**7100 Wisconsin Avenue, Preliminary Plan 120130200, Site Plan 820130230**

Staff Report Date: 6/28/13

**Description**

- **Staff recommendation: Approval of the preliminary plan and site plan with conditions**
- The Application complies with the Bethesda CBD Plan.
- Section 59-D-2.42 of the Zoning Ordinance allows an increase in both FAR and height above the master plan recommended limit to accommodate MPDUs and bonus density.
- The Applicant requested a Public Improvement Easement (PIE) in-lieu-of truncation at the Woodmont/Wisconsin Avenue intersection. The Montgomery County Department of Transportation (MCDOT), the State Highway Administration (SHA) and Planning Staff support the PIE.

Image showing the Sector Plan Height limits (purple) and the zoning height limits (blue dots). The location of the proposed building is in brown.

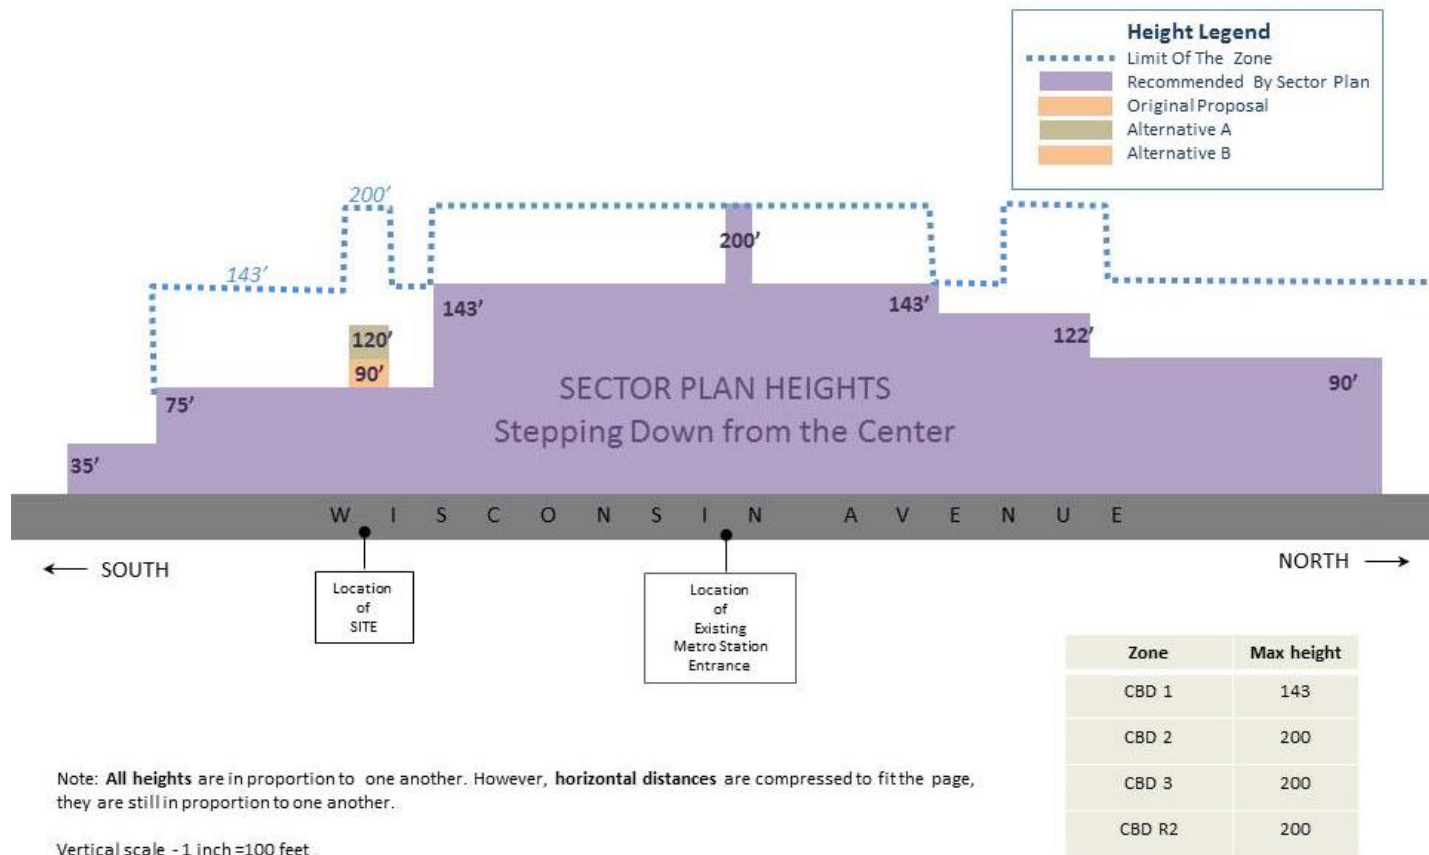
The Sector Plan recommends that the height of buildings on this site be limited to 75 feet (Pages 124 and 127). This reflects the overall Sector Plan concept for Urban Form (pages 37-40) that directs the tallest buildings to be located in the center of the CBD. Height is then to step down outward to the edges of the CBD as it approaches the adjacent existing single family neighborhoods

The Application is for a building of up to 120 feet, primarily along the Wisconsin Avenue property frontage. The length of the building is reduced along Woodmont Avenue, effectively eliminating volume and mass in one place and shifting it to another. The building starts at a height of 45 feet, then increases to 100 feet and then to 120 feet facing Wisconsin Avenue. This creates a more compatible relationship with the existing Crescent Plaza residential building, and allows more light, air and privacy for residents of the Crescent Plaza, and of the future 7100 Wisconsin building. This configuration also allows a greater number of residents of the Crescent Plaza to maintain views to the south of nearby neighborhoods. The average height along the Woodmont Avenue frontage is 87'. Numerically, this is a modest increase.

This configuration successfully achieves the intended goals and objectives of the Sector Plan; however, it is not a strict interpretation of the Sector Plan recommendation for height. The Sector Plan recommends 75 feet for several blocks along south Wisconsin Avenue, in order to step down from core to the edge. The building height still achieves a general stepping down. Its tallest portions are close to the Core and its taller heights. Its lowest portions are closest to the existing one family neighborhood outside the CBD diagonally across Woodmont Avenue. The Application achieves greater compatibility with the Crescent Plaza next door by rearranging the same yield using different volumes. The proposal therefore still provides just as much residential use including 15% MPDUs which contributes to housing choices.

While the Application exceeds both the height and density limits in the master plan, the zoning ordinance pursuant to Section 59-D-2.42 allows an increase in both FAR and height above a master plan recommended limit to accommodate Moderately Priced Dwelling Units and bonus density.<sup>1</sup> The development is found to conform to the intents and requirements of the zone relative to the Sector Plan.
